SUBJECT: **Case 01239: Non-Substantive Amendment - Bedford Waterfront Development**

SUBJECT: Case 01239: Non-Substantive Amendment- Bedford Waterfront Development

An application by Provident Holdings Ltd. to amend the Agreement for Phase 1 of the Bedford Waterfront Development. The amendment is necessary for proposed changes to 600 Waterfront Drive (Building B) on Site 3.2 of the Bedford Waterfront Development.

Building Elevations for 600 Waterfront Drive (Building B)

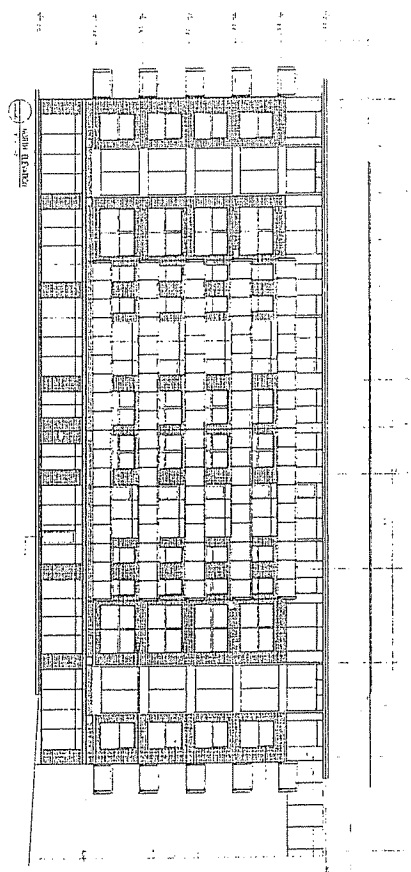
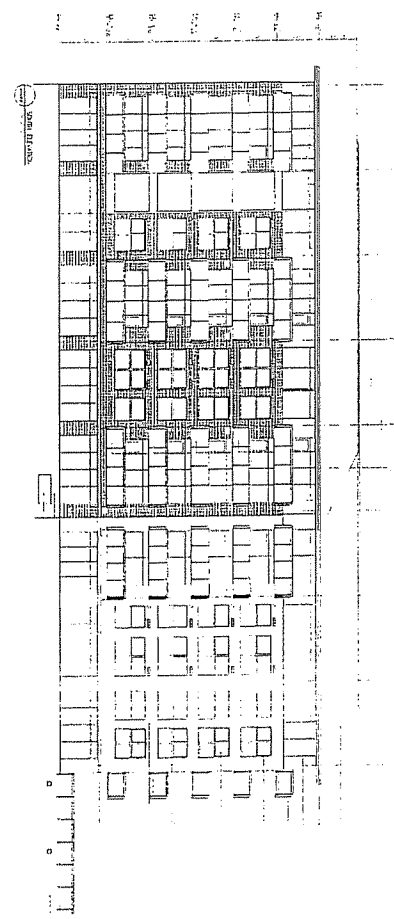
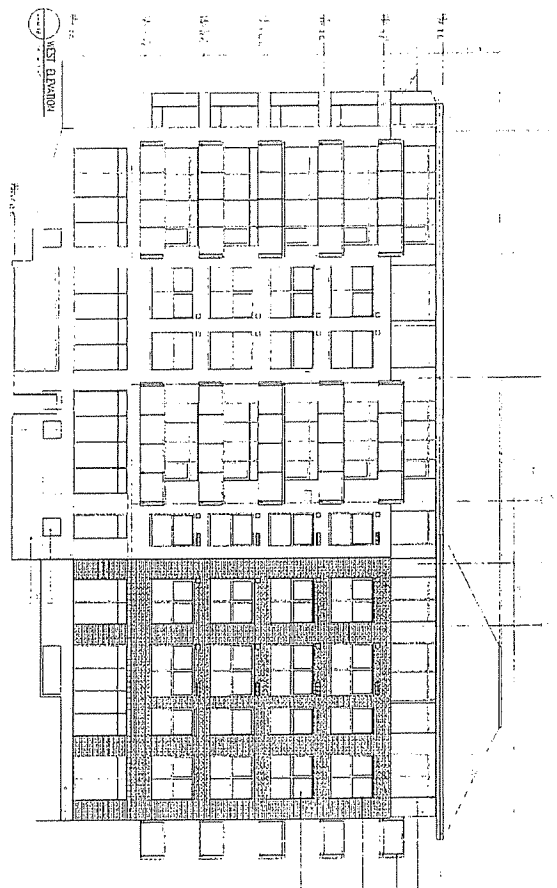
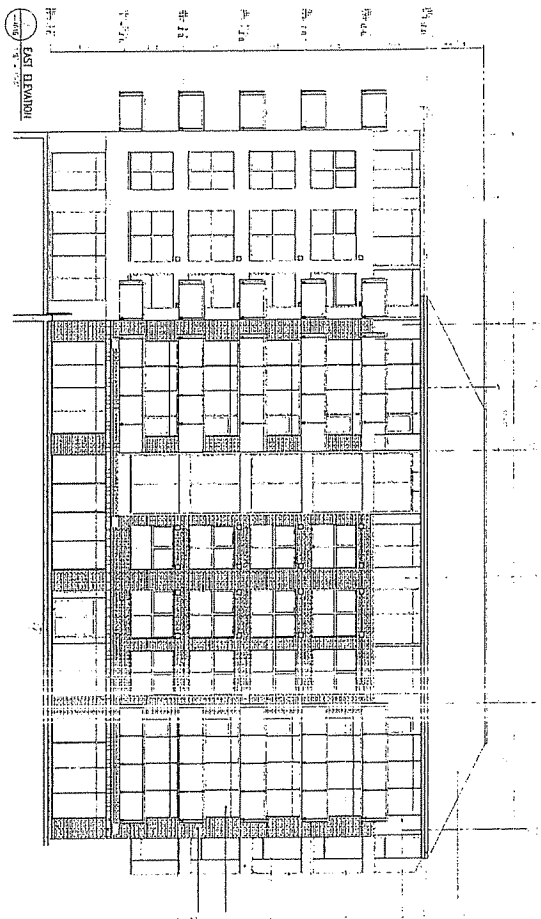
Provident Holdings Ltd's construction plans for 600 Waterfront Drive (Building B) show more window openings and different window proportions than permitted by the existing Agreements (Map 2). As the elevations do not meet the current standards, a non-substantive amendment is necessary. The history of this non-substantive amendment is as follows:

- 2009 Provident Holdings Ltd. has applied for a further amendment. The proposed design for 600 Waterfront Drive (Building B) exceeds the window openings permitted under the 2008 amendment. The design also contains a number of windows that are wider than tall. The Design Guidelines of the 1991 Agreement require square or taller than wide windows (Attachment B).

Staff are proposing to revamp the 2008 Agreement to enable the proposed changes. Staff recommend that Schedule E be removed. Strict percentages of window openings can be difficult to meet and administer. Staff are proposing that the building be consistent with the WDCL approved elevations. This would meet the design intent while providing some flexibility for the Developer and administrators.

Building Elevations for 600 waterfront Drive (Building B)

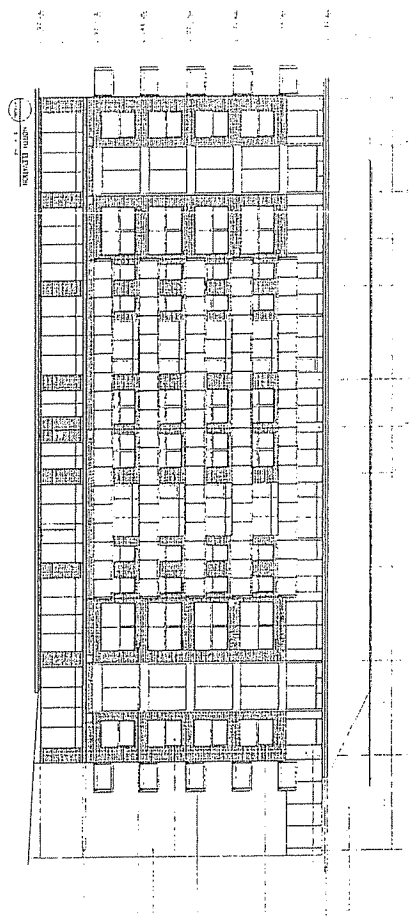
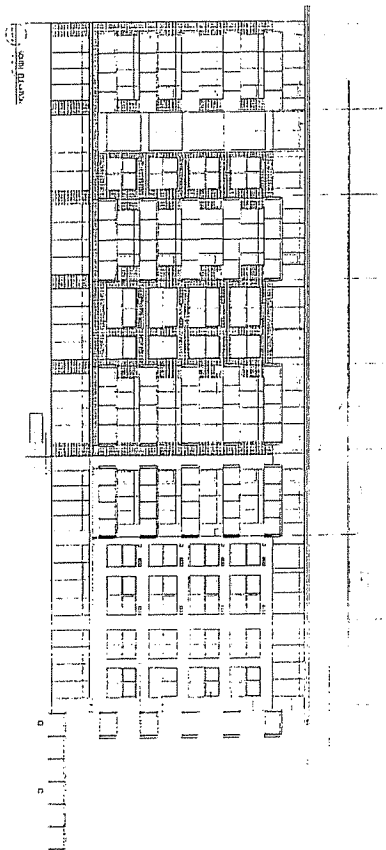
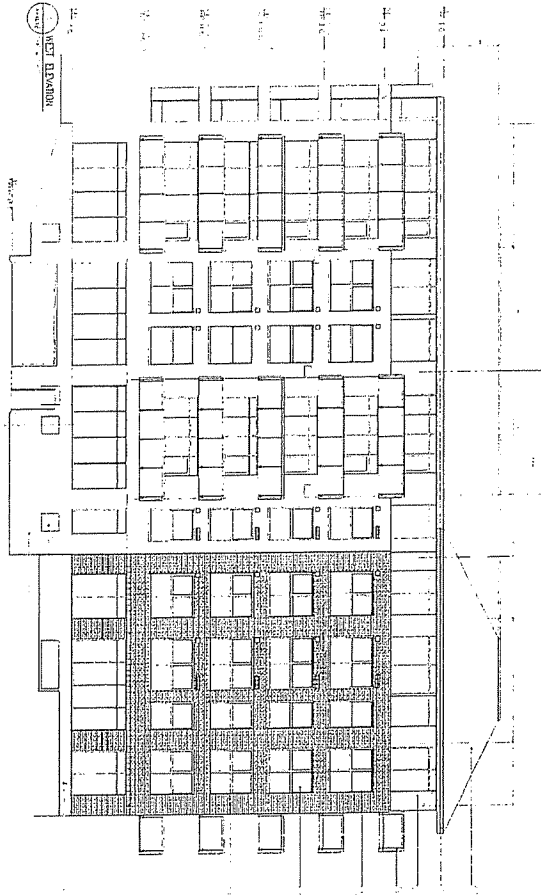
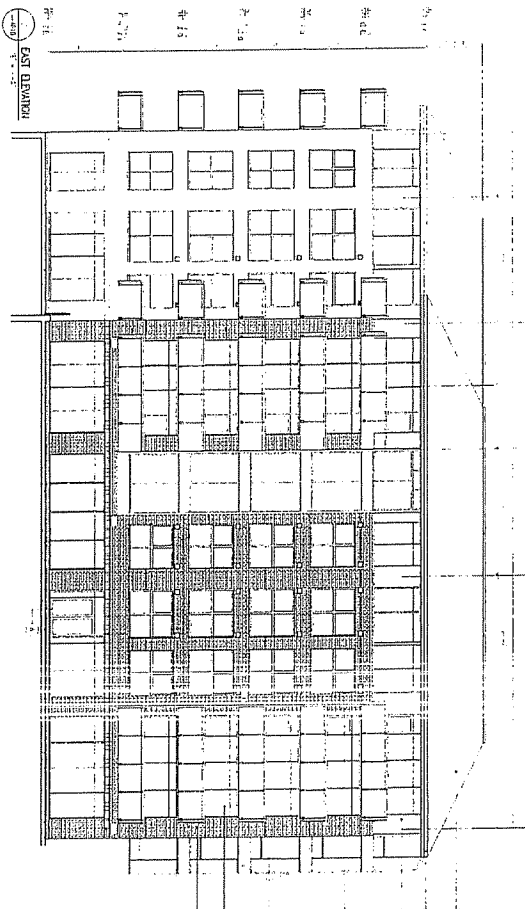
- 1. Replace original Schedule C-2: "Building Elevations for 600 Waterfront Drive"

Schedule C-2: "Building Elevations for 600 Waterfront Drive (Building B)"

- 2. Remove Schedule E: "Maximum Window Openings/Wall Area Ratios"
- 3. Amend Part 3 by replacing the following text:

3.1 Schedule E, Sub-section 1.5.2 of the Existing Agreement be amended to relax the Bedford Waterfront Development Corporation Design Guidelines for the 5 storey and 6 storey buildings on Site 3.2 (Buildings A and B, a.k.a 400 and 600 Waterfront Drive) to permit the following:

- 1. increased window openings;***
- 2. horizontal bands of glazing; and***
- 3. width to exceed height.***

3.2 The 5 storey and 6 storey buildings on Site 3.2 (Buildings A and B, a.k.a 400 and 600 Waterfront Drive) shall be as generally as shown in Schedules C-1 and C-2.
